To:	Arun District Council	From:	Envireau Water
Ref:	2449 Eric Wall Longacre GH&Res \ TN2 Query Response.docx	Pages:	5 + Figures + Appendices
Re:	Glasshouse and reservoir development, Maypole Lane, Yapton (Y/92/15/PL)	Date:	23/01/19

Following submission of TN1, Arun District Council raised 14 comments regarding the proposals in an email dated 7/12/2018. The response to these comments is provided in the following section. This technical note (TN2) should be read in conjunction with TN1.

2 RESPONSE TO COMMENTS

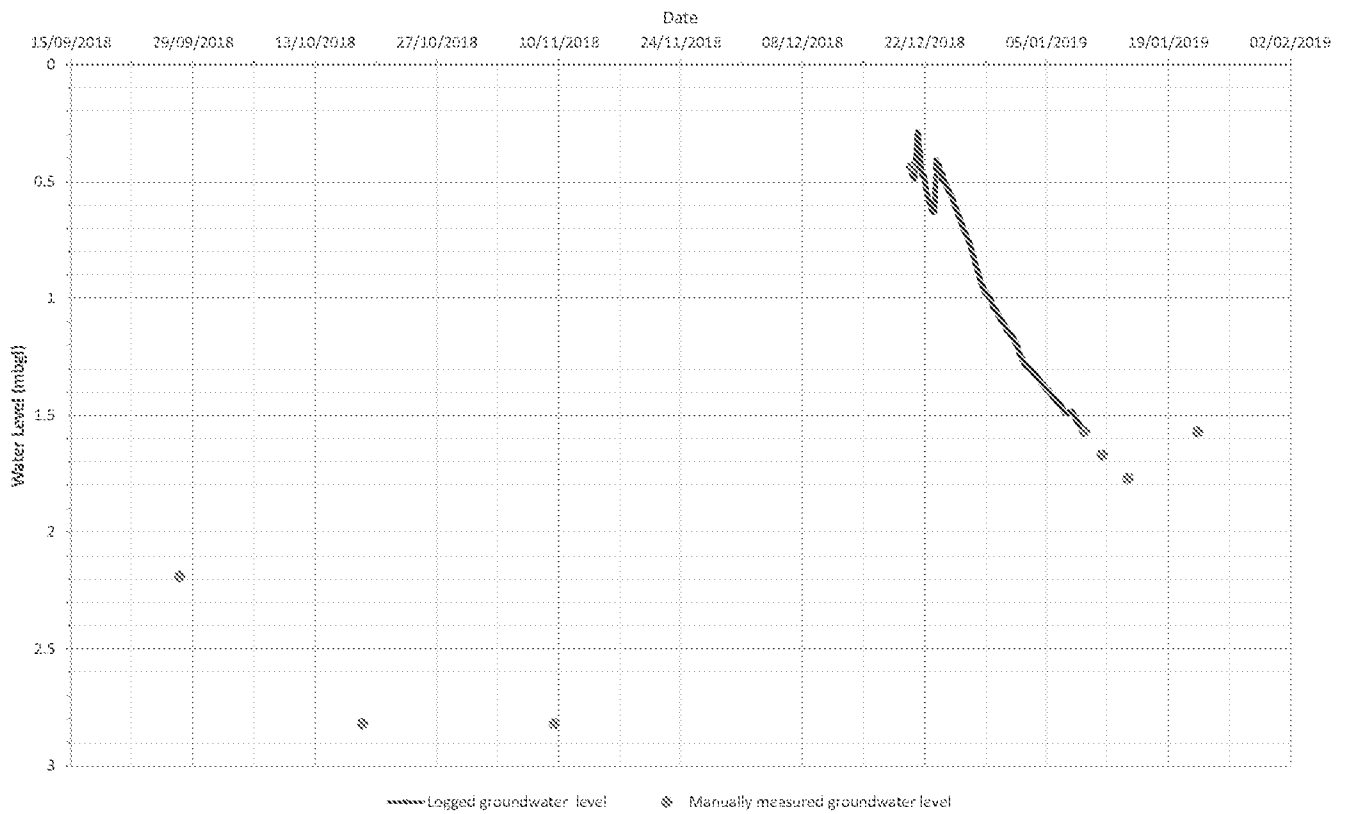
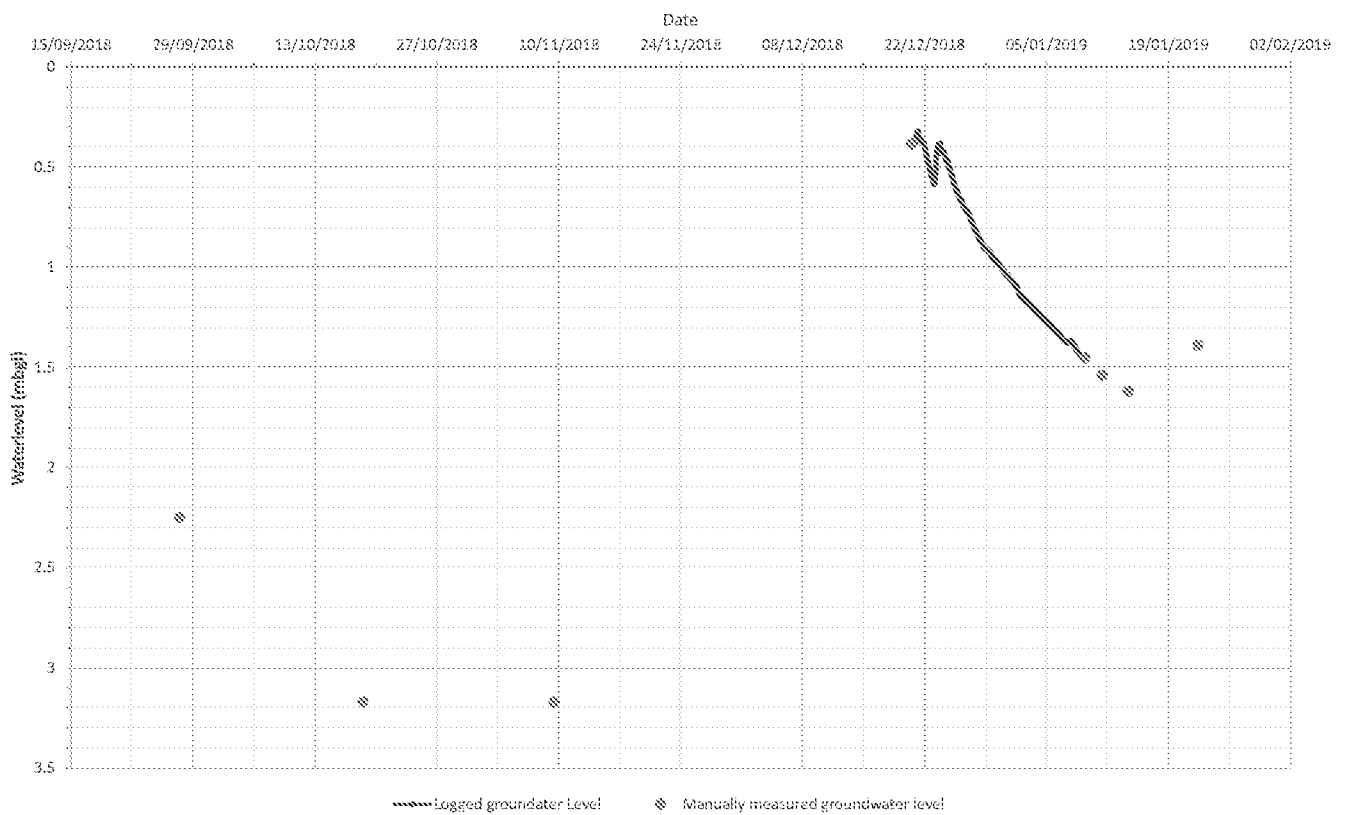
2.2 *Groundwater was found to be a lot lower than we expected, I note that winter monitoring has not occurred at the locations where infiltration is proposed. This will need to occur.*

TN2 - Figure 5 shows two graphs, one for TPS2 and one for TPS3. Groundwater levels in September, October and November 2017 were between 2 and 3.2mbgl. In mid-December, groundwater levels increased to c. 0.4mbgl responding quickly to rainfall recharge. Rapid response is illustrated by the peak on 23 December 2018. The continuous fall in groundwater level over the following 18 days illustrates the free draining nature of the geology and the rapid fall in groundwater levels below 1mbgl.

Eastern Bank of Reservoir

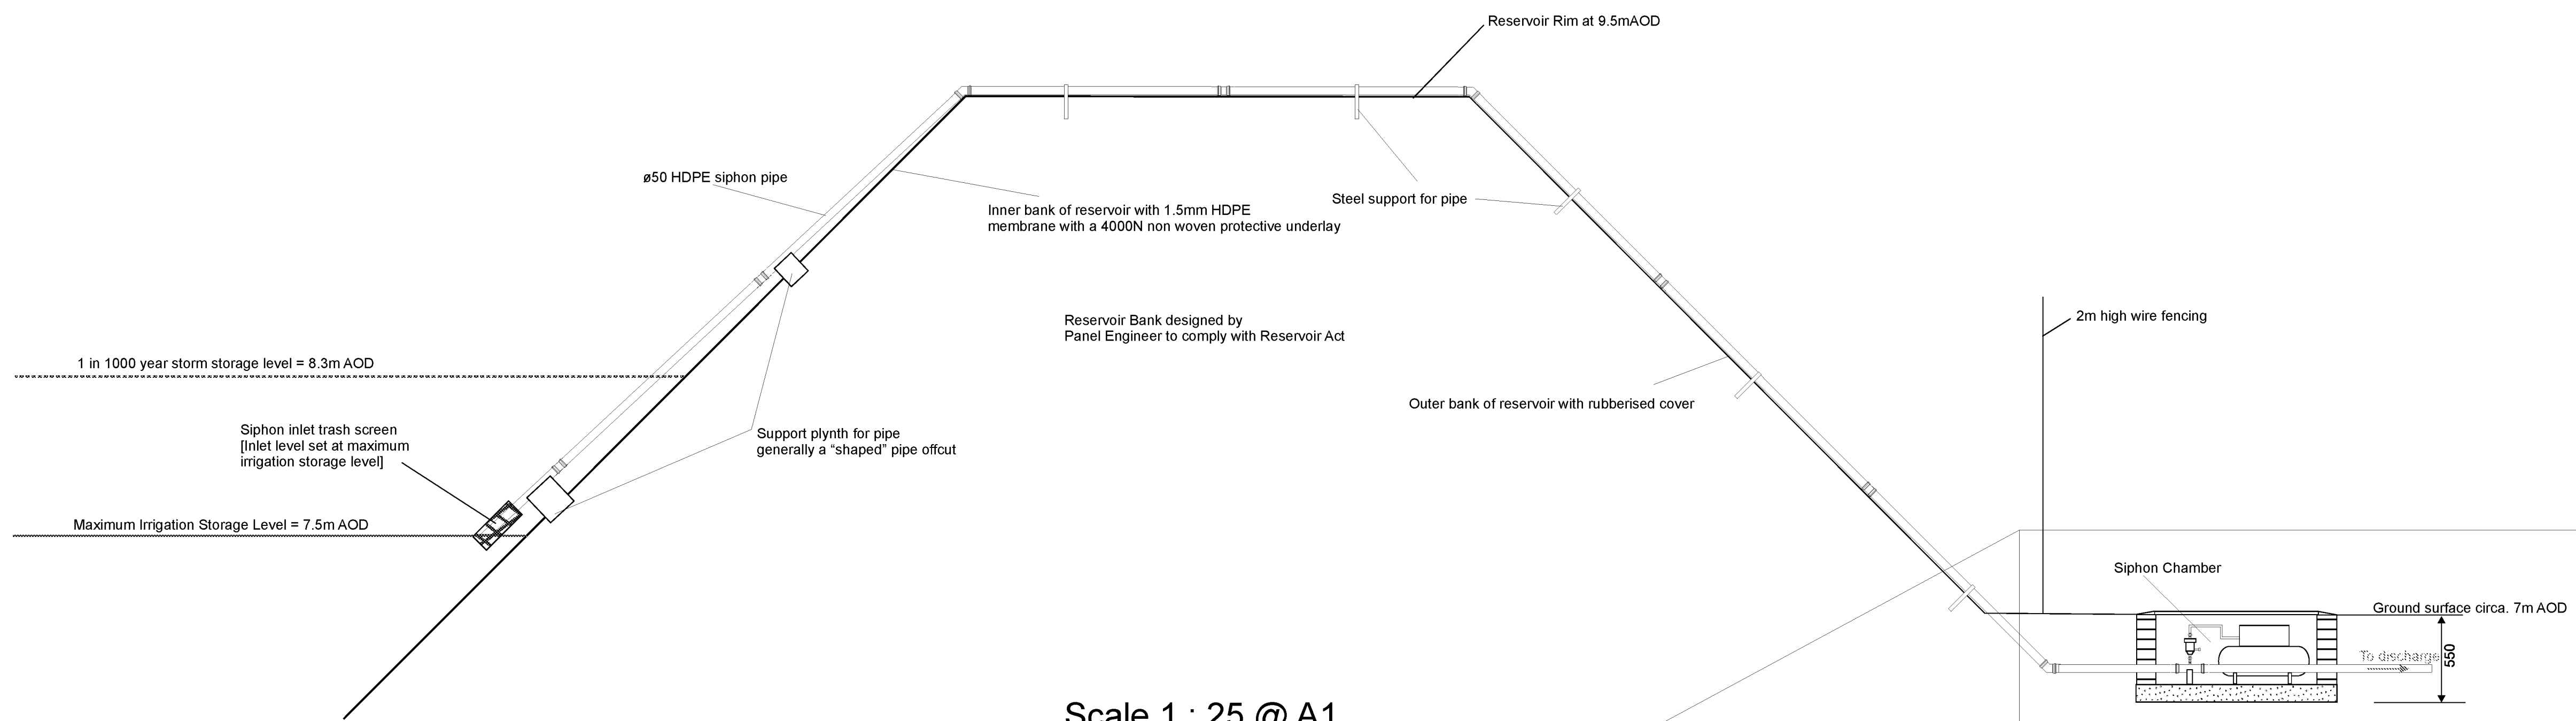
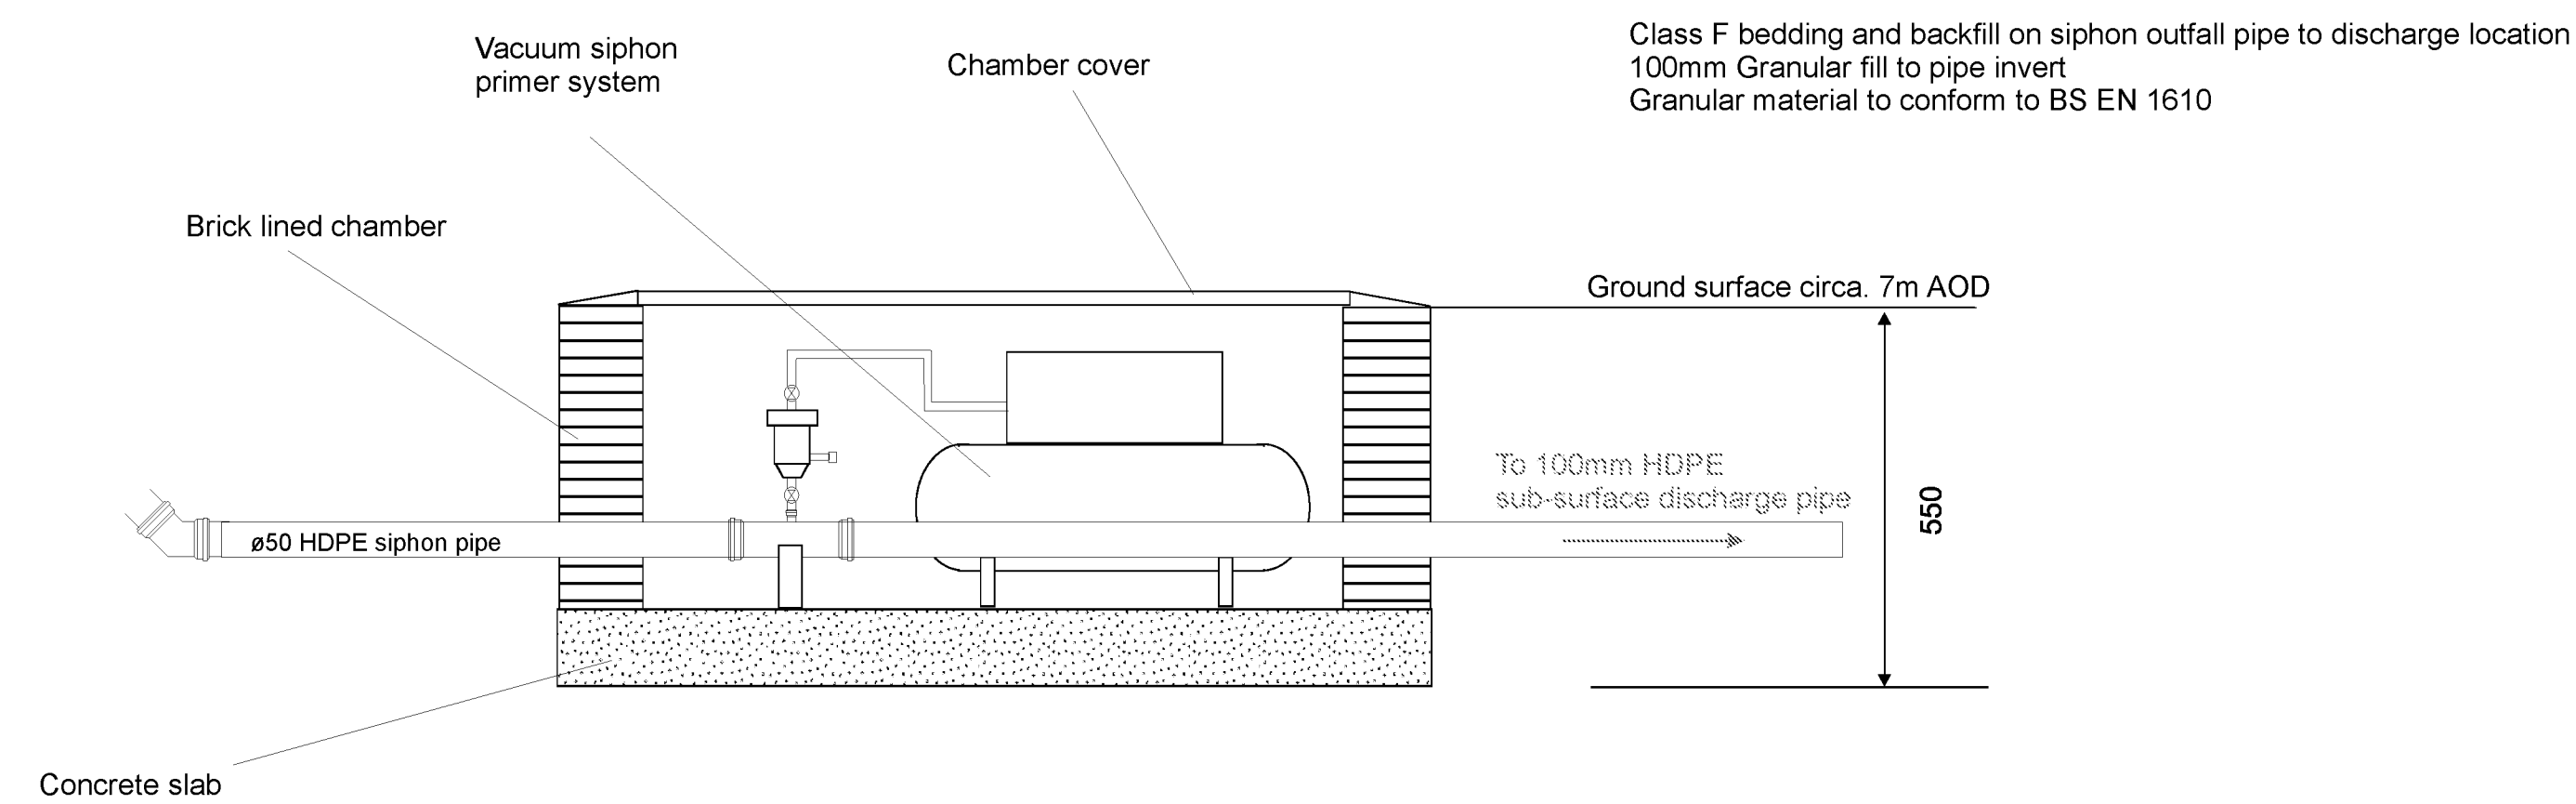
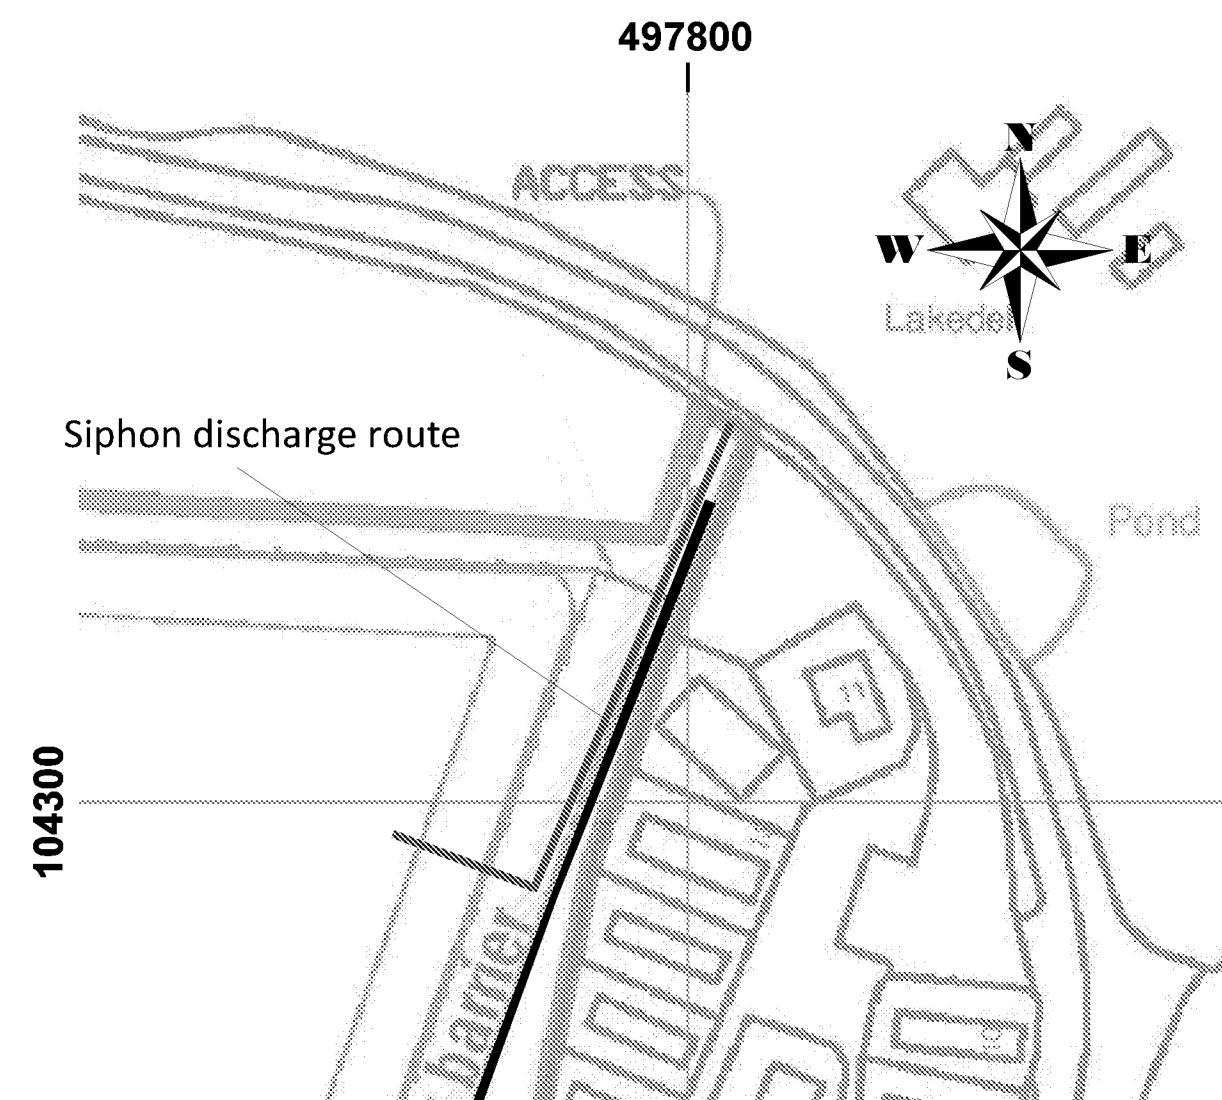
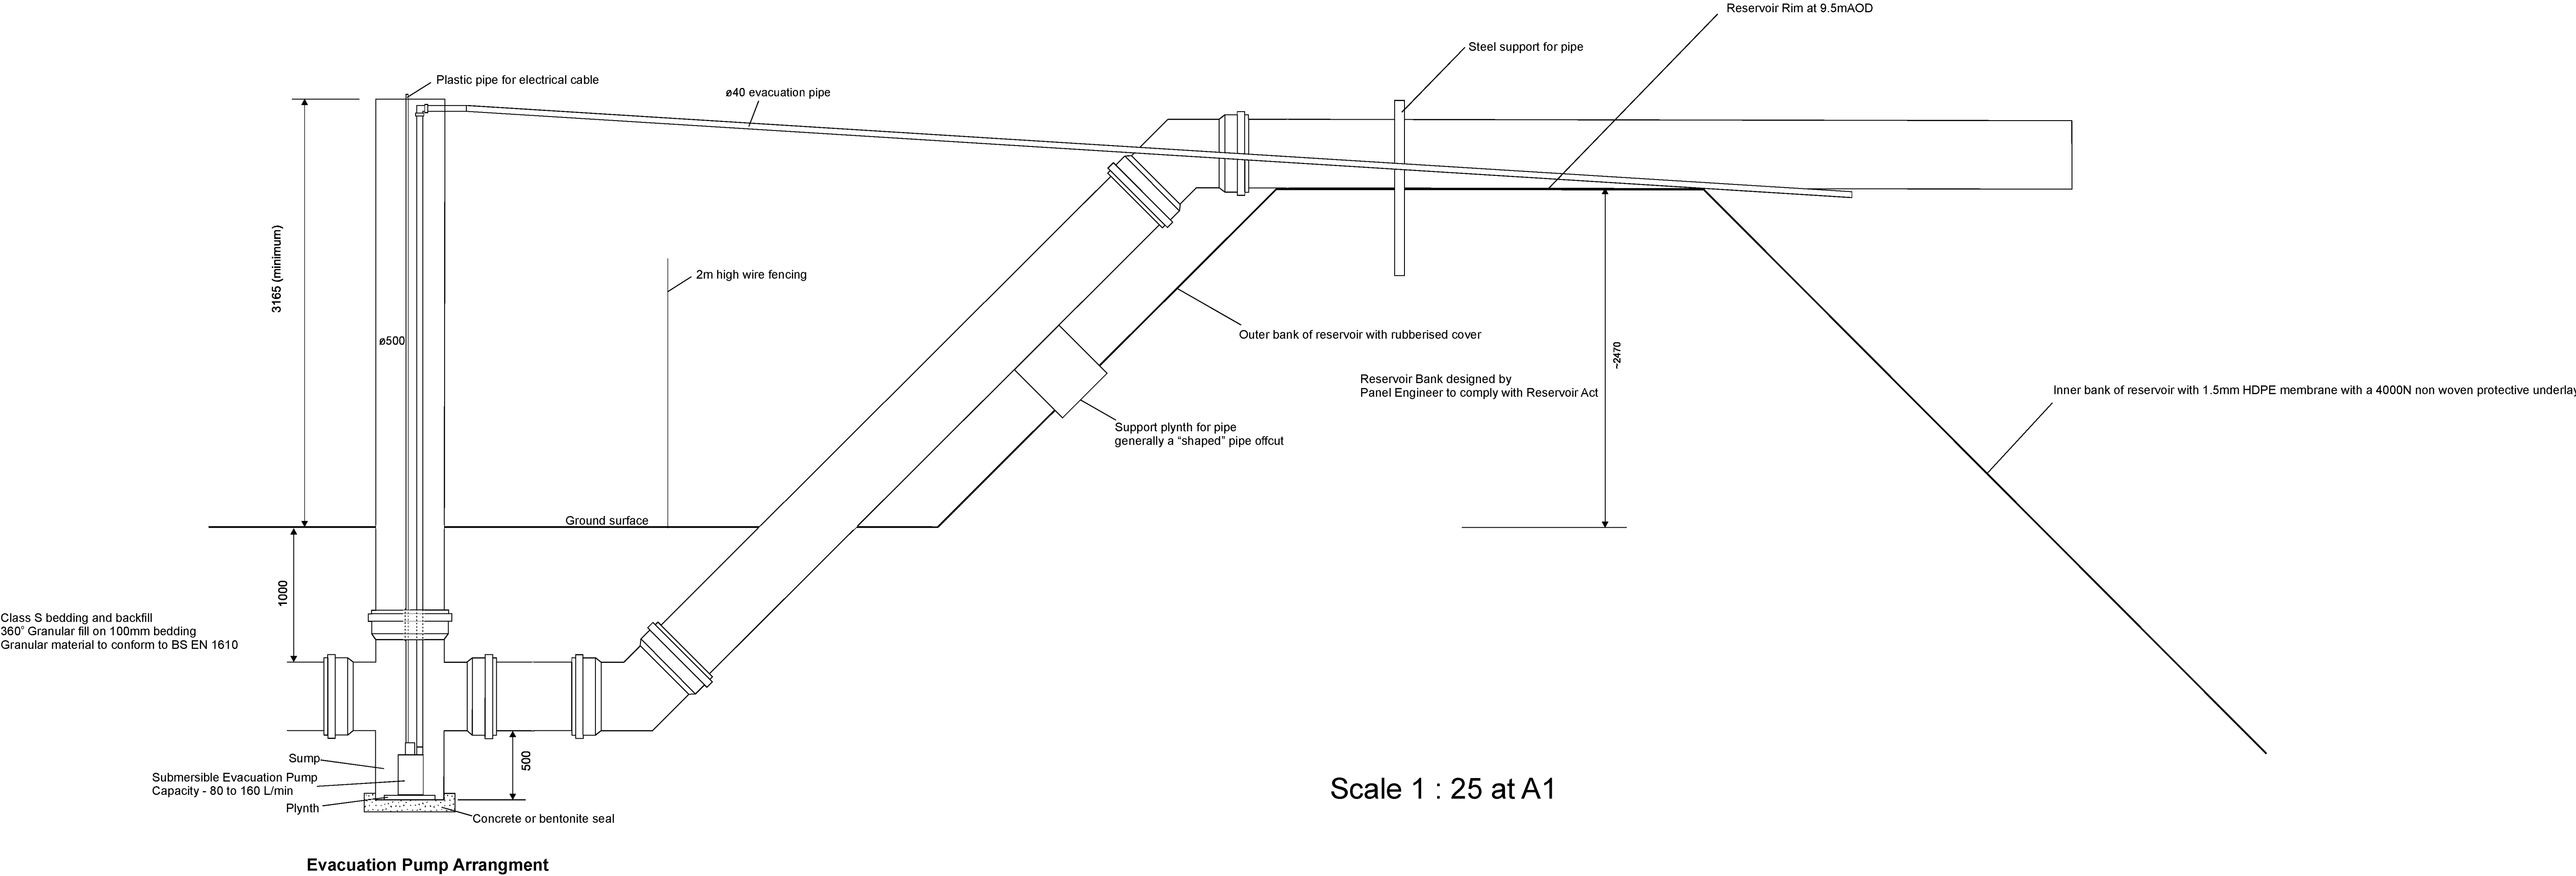
2.4 I presume that the siphon invert level is the control on the maximum water depth stored within the reservoir for irrigation purposes?

That is correct. The siphon invert level is the control level on the maximum water depth stored within the reservoir for irrigation purposes. Details of the siphon are provided in TN2 Figure 6. The siphon system will have an air vacuum primer system for ease of start-up and control of flow rate. The siphon pipe will be a 50mm HDPE pipe to allow a maximum flow of 2.5 l/s.

The siphon invert will be set at 7.5mAOD, 2.0m below the rim of the reservoir.
